September 2010
Hakko Electronics Co., Ltd.

Re: Precautions against the System Program Modification for V606e Series

*1 Error message appeared on the configuration software

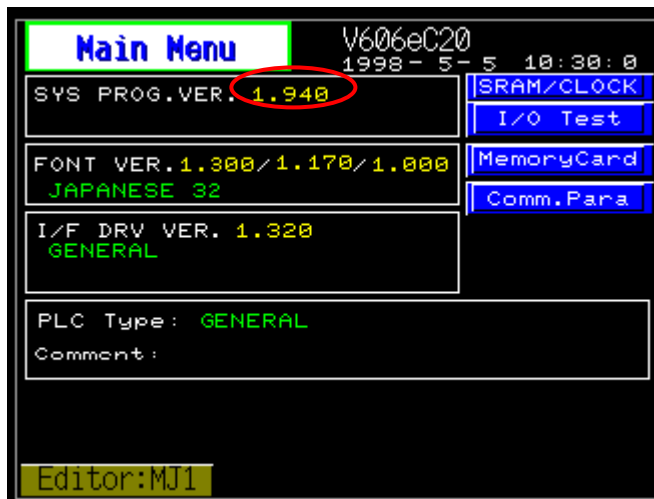
“There is a matching error in the system program. The system program in this version cannot be transferred because of the difference in hardware. Check the version.”
